## AIRPORT INDUSTRIAL PARK AT ORLANDO (AIPO) No. 23 (REPLAT)

### SUMMARY

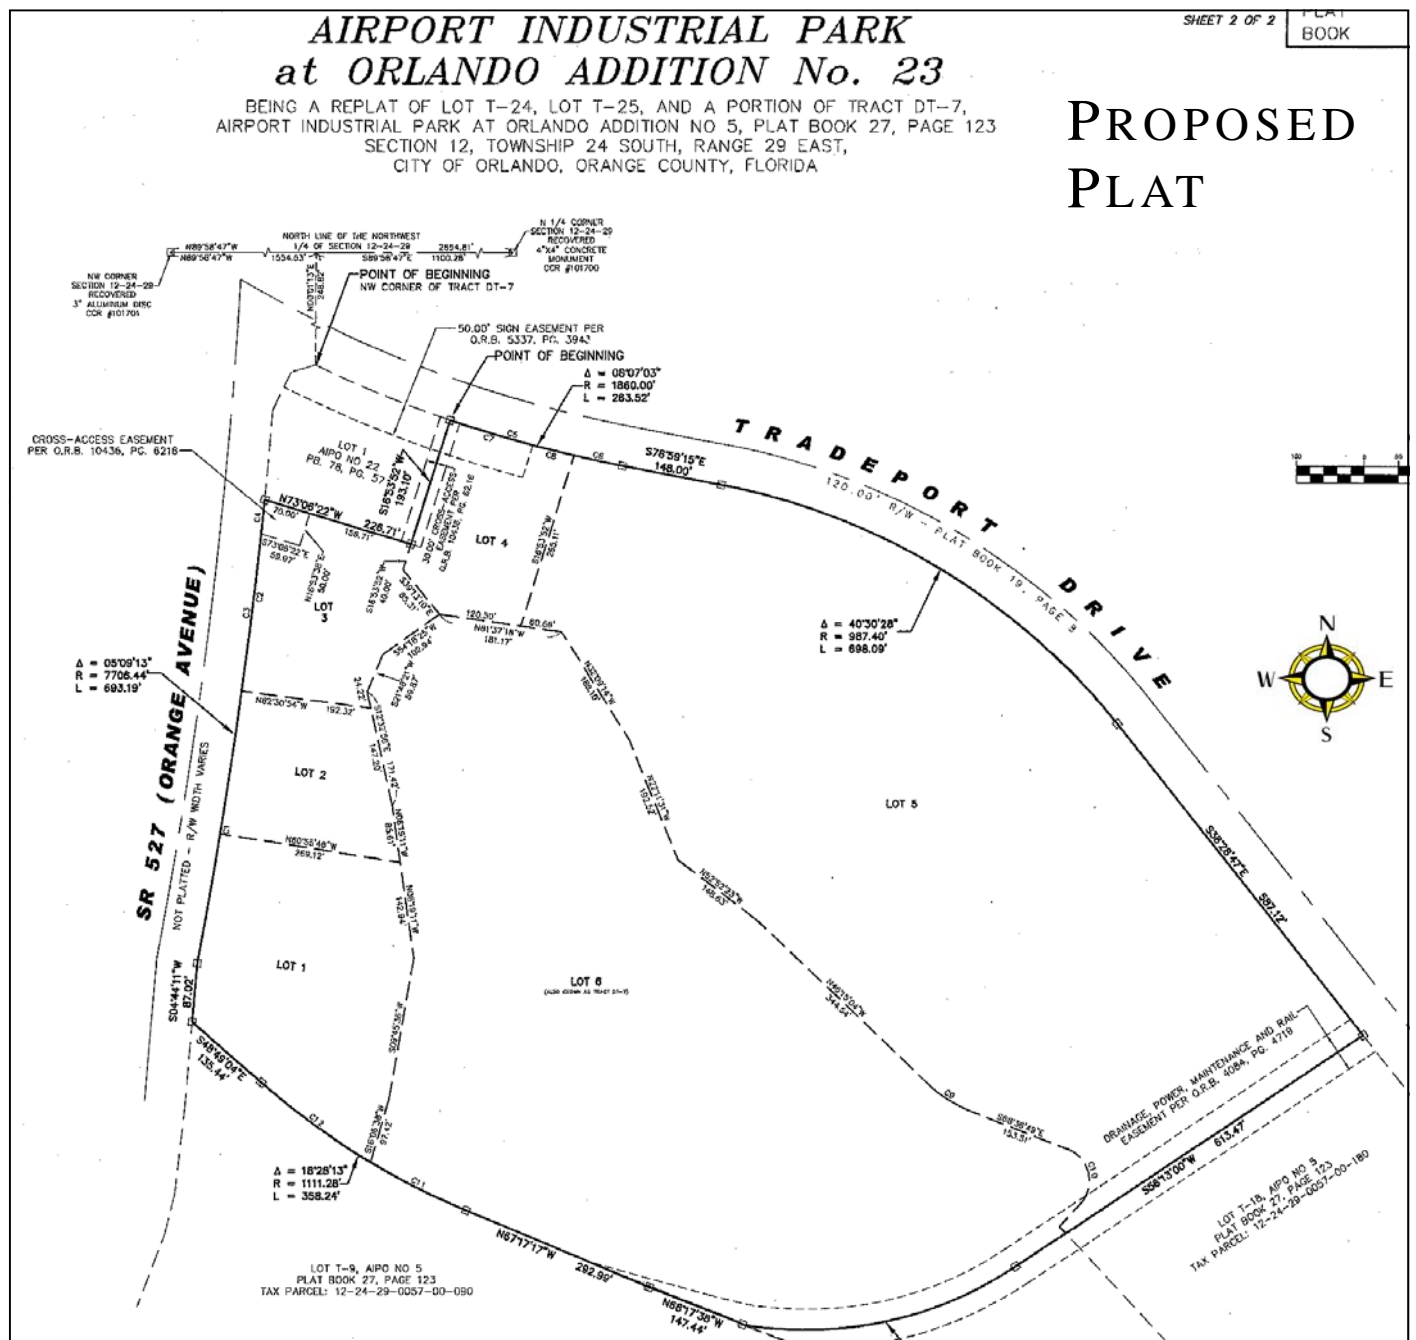
1. Cross-Access - The subject development shall provide cross-access easements between lots one (1) through three (3) and between lots four (4) and five (5) to ensure that parking, access, and circulation may be easily tied in to create a unified system.
2. Existing Easements - The thirty-five (35) foot private landscape, utility, and drainage easements shown on the submitted survey are not called out on the proposed plat. If these private easements still exist, please call those out on the face of the plat.
